AP-425 RETROFIT

This Engineering Bulletin presents the latest improvements carried out to the **High Level Palletizer (AP-425) Overhead** turner re-design. This new design is now standard on our new **AP-400 series** and available as a retrofit. 100% retrofit with the majority of **AP-425**

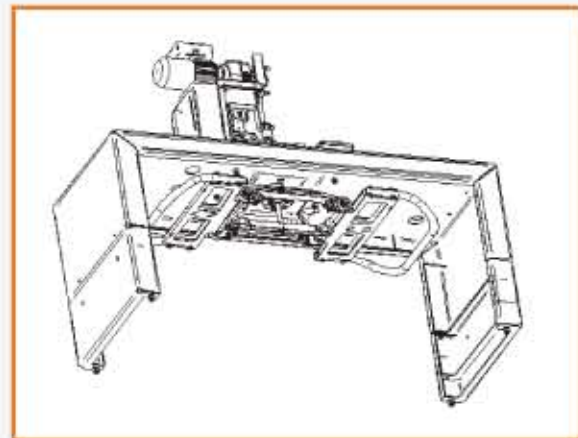
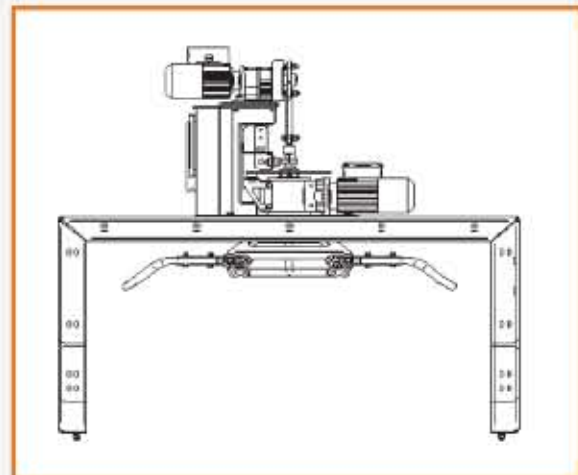
- Re-designed flaps for a smoother manipulation of the bags or bales
- Quicker and more precise movement through lighter design (50% less weight)
- The main shaft is no longer welded to the turner for easy manipulation
- Increased reliability through stronger construction & less need for adjustment
- Uses the same gearmotors as the previous design thus reducing the cost of the retrofit

- Less maintenance and adjustments required by removing the tension springs and adjustment chains
- Lubricated bushings eliminates greasing points on the main shaft
- Smoother movements due to less moving parts
